January 31, 2017

**Reference: Response to Report Comments**  
**Remedial Investigation Report**  
**Philadelphia Refining Complex AOI 1**  
**3144 Passyunk Avenue, Philadelphia, PA 19145**

Figure No.  
**5-8**

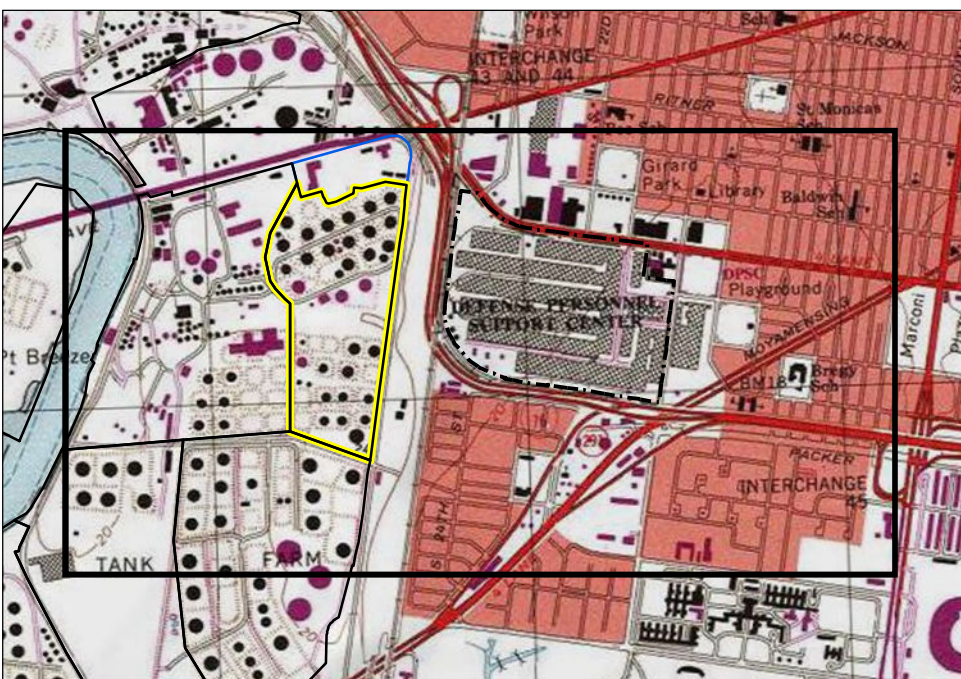
**Comment #4:** *"In Figure 5-8 Stantec contoured the differential groundwater elevations using data from well pairs screened in the water table and deep aquifers. The figure indicates a large negative head differential, implying upward flow, along the 26th Street sewer around the Pollack Street sewer intersection. This appears to be almost entirely an artifact of the contouring, as there are no well pairs with such large head differentials (~2'). Also, the contours do not match some of the data (e.g., S-389D, S-390D). I suggest you remake the figure to show only the differential elevations at each location rather than contours."*

**Comment #5:** *"The low areas along 26th Street in Figure 5-8 appear to be a consequence of lower heads in the unconfined aquifer wells rather than higher potentials in deeper aquifer wells. So the apparent upward vertical gradient there may not reflect an influence of the 26th Street sewer line on the lower aquifer. (Compare Figures 5-6 and 5-7.)"*

**Response to Comment #4:** A revised copy of Figure 5-8 is attached to this response letter. In the revised figure, two changes have been made: the colorized grid showing head potentials between the unconfined and lower aquifers has been removed, and at lower aquifer well locations S-389D and S-390D the paired wells S-205 and S-207 have been removed. Those wells should have been boxed in the figure to indicate that they were not utilized in contouring of the May 2015 dataset due to anomalous water-level elevations (i.e., interpreted to be influenced by perched groundwater within fill). In the attached version, alternative wells S-396 and S-403 have been included for the evaluation of head differentials between the aquifers defined in the RIR near those locations.

Although removed, it is noted that the grid originally presented in RIR Figure 5-8 did not represent an interpolation of differential groundwater elevations at well pairs but was the product of grid math (i.e., equidimensional grids were produced for both aquifers and the lower aquifer piezometric surface was subtracted from the water-table elevation surface at each grid cell). Stantec used this information on a conceptual level to evaluate the potential for vertical exchange of groundwater between the aquifers under current hydraulic conditions. Although the higher well density in the unconfined aquifer along 26<sup>th</sup> Street is largely responsible for the pattern shown (as opposed to higher heads in the lower aquifer), the potential for negative differentials of the magnitude estimated by the grids may exist. Evaluation of head potentials between aquifers in this area of the complex will continue and may be presented in future Act 2 submittals, as appropriate.

**Response to Comment #5:** When viewed independently of the water table, the lower aquifer piezometric surfaces presented in RIR Figures 5-6 and 5-7 both show flow convergence or lower heads in proximity to 26<sup>th</sup> Street along the No. 2 Tank Farm when compared to the surrounding area. It is Stantec's opinion that the flow convergence in this area may be the manifestation of head losses in the lower aquifer due to leakage into the 26<sup>th</sup> Street Intercepting Sewer, either
